**OFFICE OF ENERGY INFRASTRUCTURE SAFETY**

To: 2022 Wildfire Mitigation Plans docket (#2022-WMPs)  
Subject: Decision on Pacific Gas and Electric Company's 2022 Wildfire Mitigation Plan Update

**OFFICE OF ENERGY INFRASTRUCTURE SAFETY'S  
FINAL DECISION ON 2022 WILDFIRE  
MITIGATION PLAN UPDATE**

**PACIFIC GAS AND ELECTRIC  
COMPANY**

Figure 4.2-3: Net Change from 2021 to 2022 WMP Reporting Period (\$ Thousands)

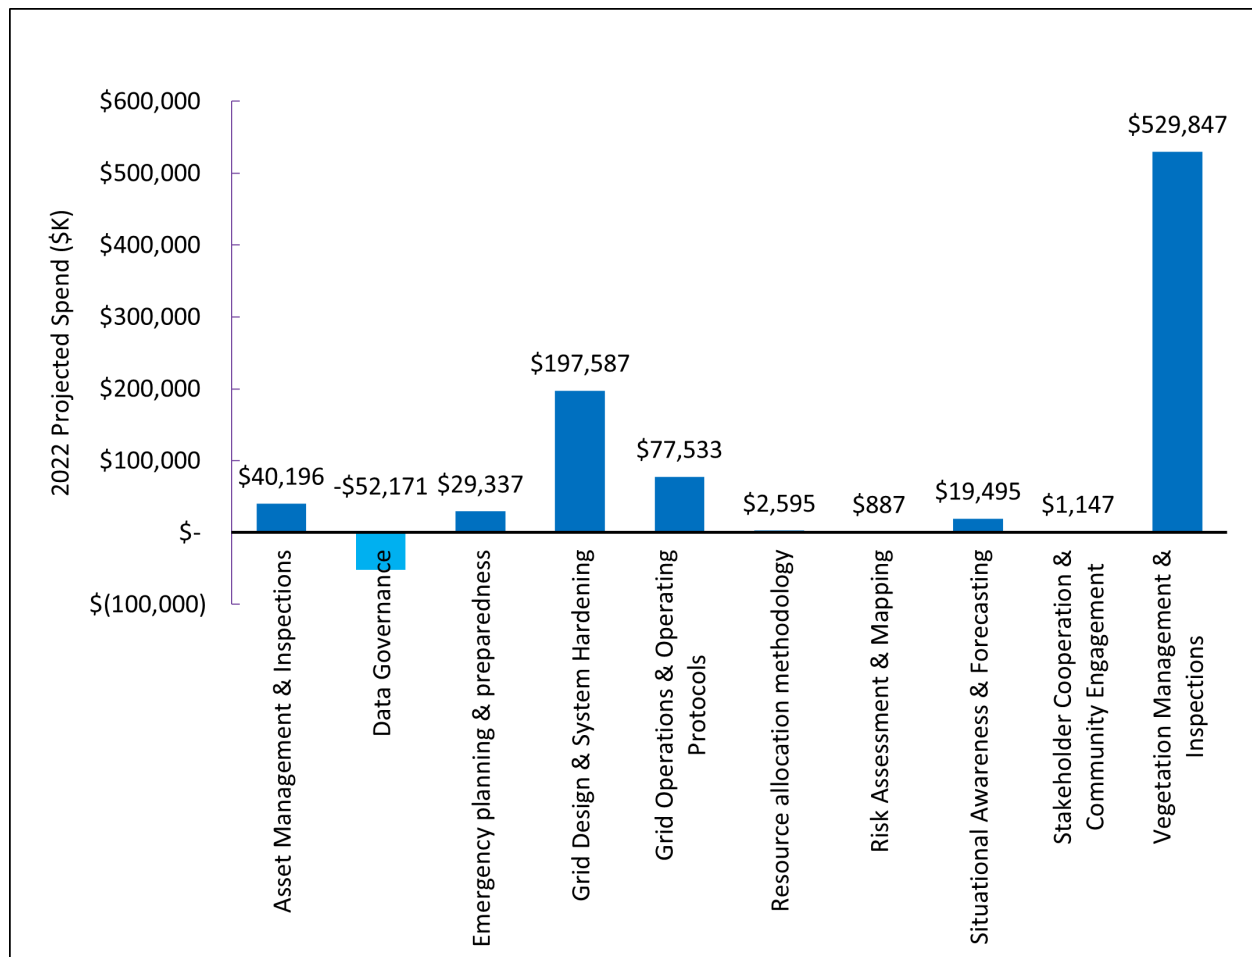
Energy Safety requested additional information about the largest changes in mitigation category spending when comparing expenditures included within PG&E's 2022 Update to expenditures projected for 2022 in PG&E's 2021 Update, as shown in Figure 4.2-3. Energy Safety asked about the following category expenditure changes:

Figure 4.6.1-6: PG&E Wildfire Distribution Risk Model (WDRM) V2 vs. V3 Risk Scores<sup>96</sup>

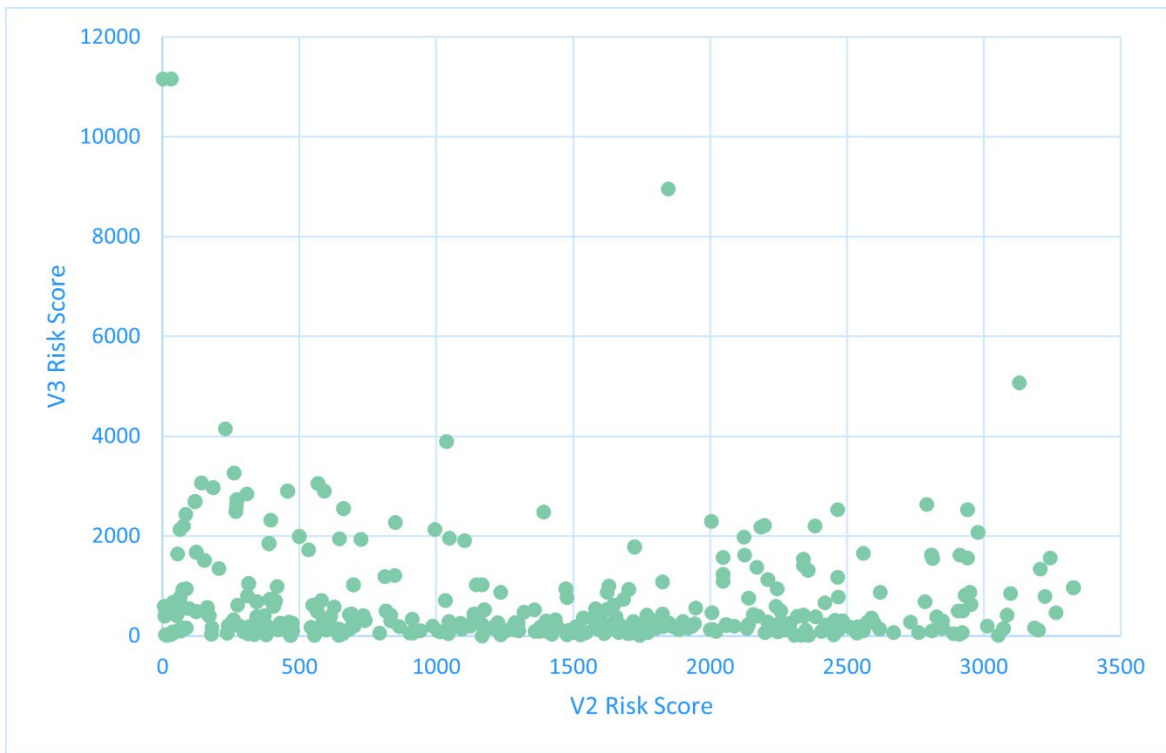
PG&E moved from Version 2 (V2) of the WDRM to Version 3 (V3). While prioritization shifts were not as drastic as those seen when adopting V2 of the WDRM, this transition did lead to a distinctive shift in prioritization. For the undergrounding projects from 2024 to 2026, no observable correlation between the V2 and V3 risk scores can be seen, as shown in Figure 4.6.1-6.<sup>94</sup> Additionally, when looking at all Circuit Protection Zone (CPZ)<sup>95</sup> risk scores, it is clear that the V2 scores lie throughout the cumulative V3 risk, with few being in the top 60 percent of cumulative risk, as shown in Figure 4.6.1-7. While Energy Safety supports improvements being made to PG&E's risk models, it is concerning that the output of risk scores continues to change in relatively drastic ways, leaving open the question of the validity not only of past models, but the current one given anticipated additional future improvements. PG&E must demonstrate an understanding of the impact of the changes made between its V2 and V3 models in order to further validate continued confidences in the risk model outputs, particularly relating to projects that may be stranded due to changes in prioritization.

Figure 4.6.4-2: PG&E's Maturity Survey Responses for All Asset Management and Inspections Capabilities (2020-2022)

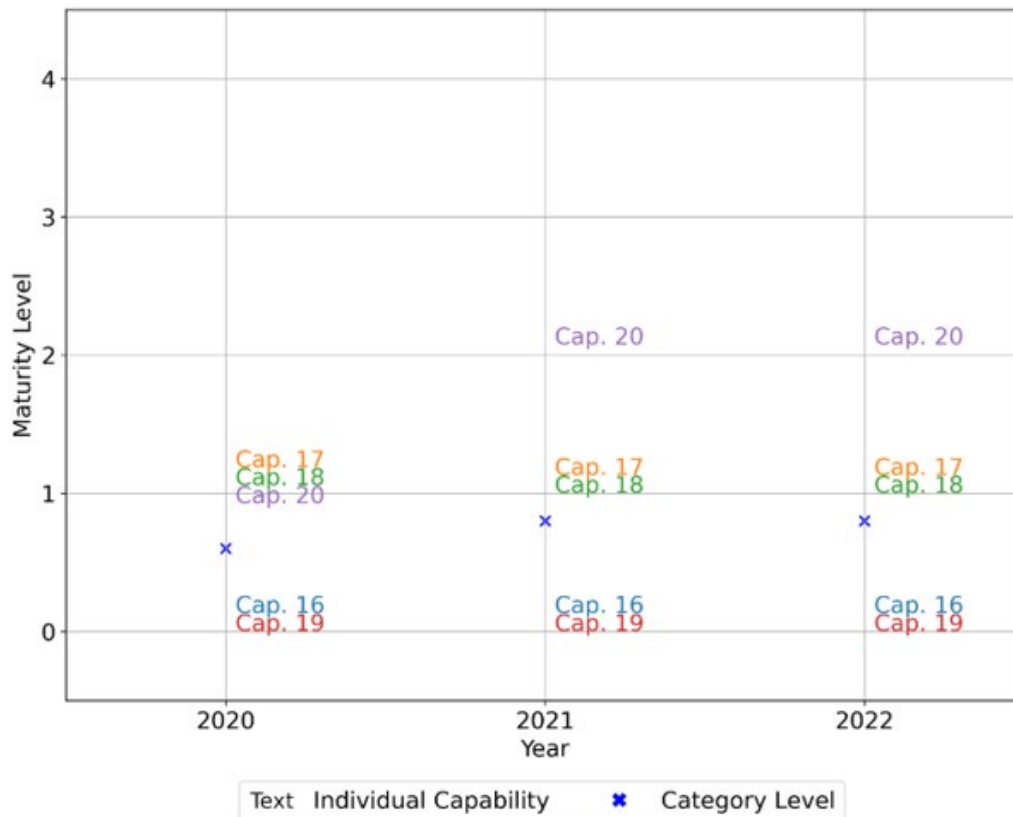
While PG&E has improved its overall maturity in the past three years, moving from 0.6 to 1.2, PG&E still remains behind its peers, as seen in Figure 4.6.4-1. Quality assurance and quality control (QA/QC) is the primary asset management and inspections capability in which PG&E is improving, as seen in Figure 4.6.4-2.

Figure 4.6.4-5: Distribution Tags based on Closing Backlogged Tag Goals

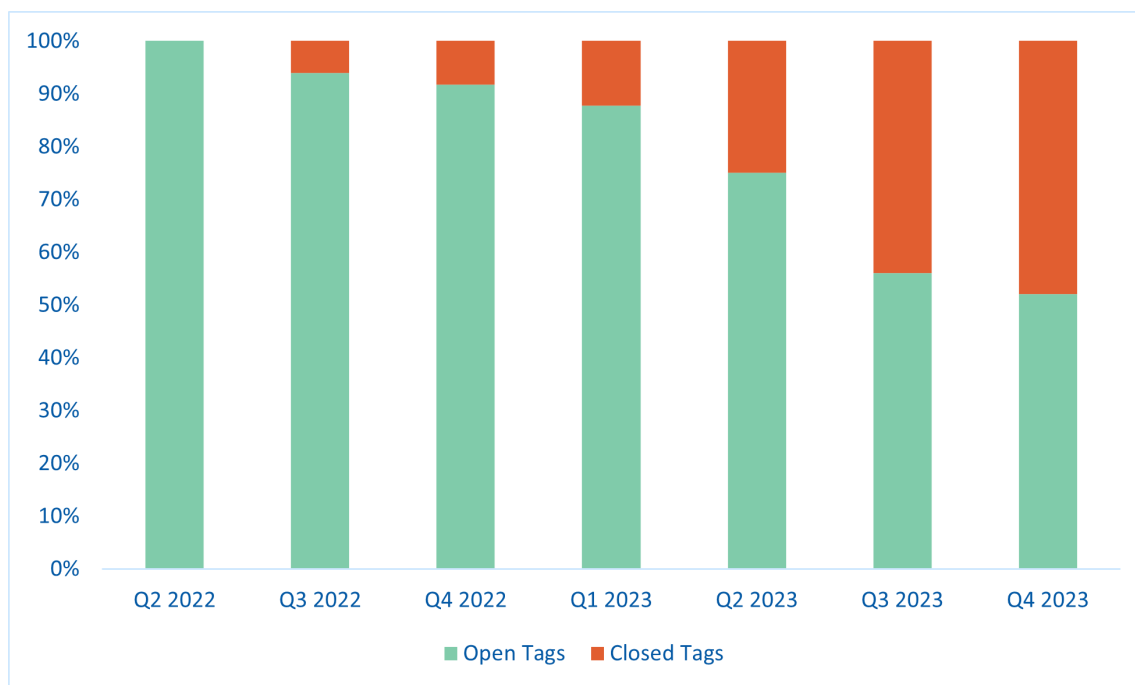
Despite providing quantitative goals to address the work tag backlog, PG&E is still creating more work tags than it is closing, as shown in Table 4.6.4-1. In the Revision Notice, Energy Safety discussed addressing the backlog by setting targets in which PG&E closes more work tags than it opens. Even with the goals provided in PG&E's Revision Notice Response, 52 percent of the open work tags for distribution will still be open at the end of 2023.

Figure 4.6.4-6: PG&E's Changes to Projected Distribution Ignitions<sup>153</sup>

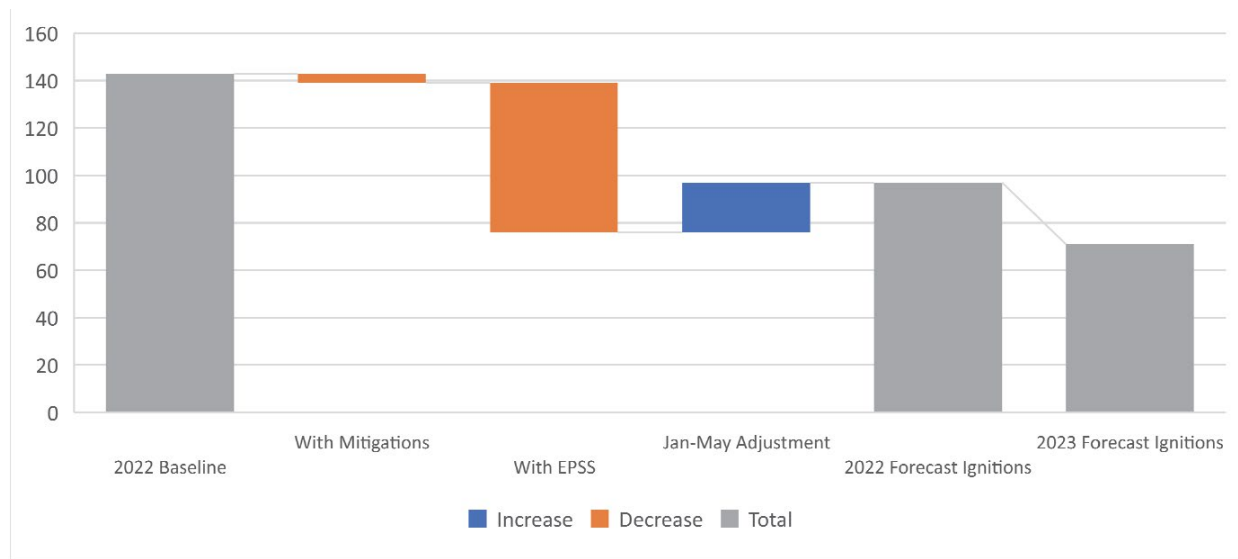
As shown in Figure 4.6.4-6, most of the decreases in the 2022 baseline ignitions are due to EPSS implementation, with minimal decrease from additional initiatives outside of EPSS. PG&E stated that, excluding EPSS, it expects ignitions to decrease by 3 percent from 2021 to 2022, and by approximately 7.4 percent from 2022 to 2023.

Figure 4.6.5-3: PG&E’s Tree-related Outage Data and Trend Line<sup>181</sup>

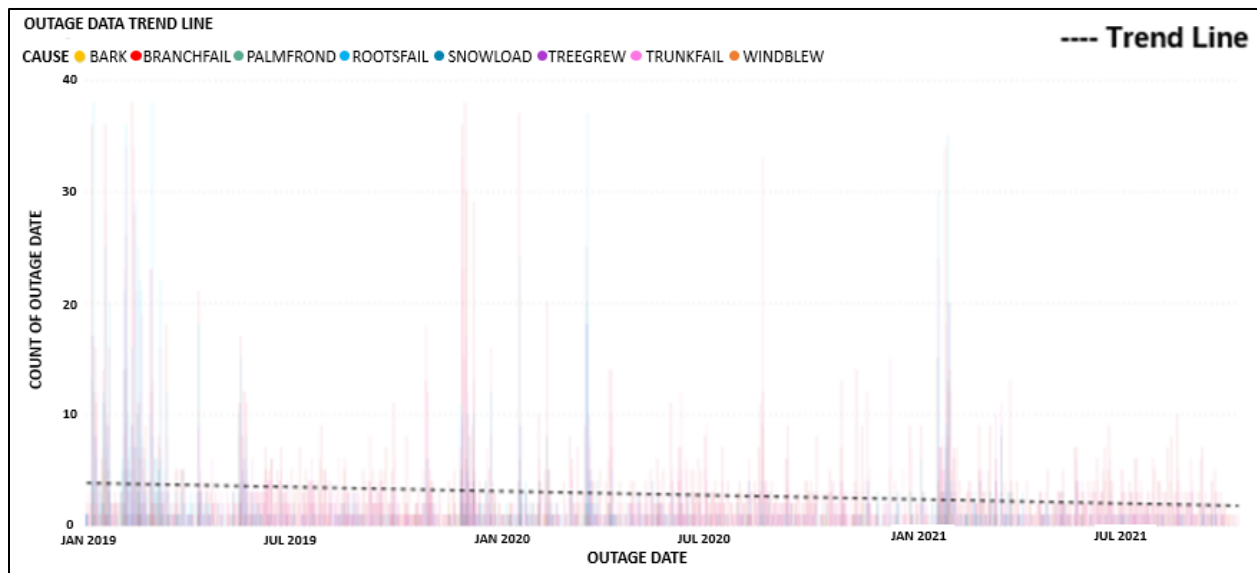
PG&E examined outage data confirmed as tree-related events and the distinct causes<sup>179</sup> of the outages since the inception of its EVM program in January 2019. PG&E’s analysis shows a decrease in tree-related events over the three-year period (Figure 4.6.5-3). PG&E acknowledges that “this data is preliminary and the decreases in tree-related causes cannot be attributed solely to enhanced clearances without further examination.”<sup>180</sup> Energy Safety’s analysis of the data it receives on a quarterly basis from PG&E does not show any trend (decrease or increase) in the number of vegetation-caused outages and ignitions on PG&E’s grid (Figure 4.6.5-4). Energy Safety’s analysis does not negate PG&E’s, nor does PG&E’s analysis negate Energy Safety’s.
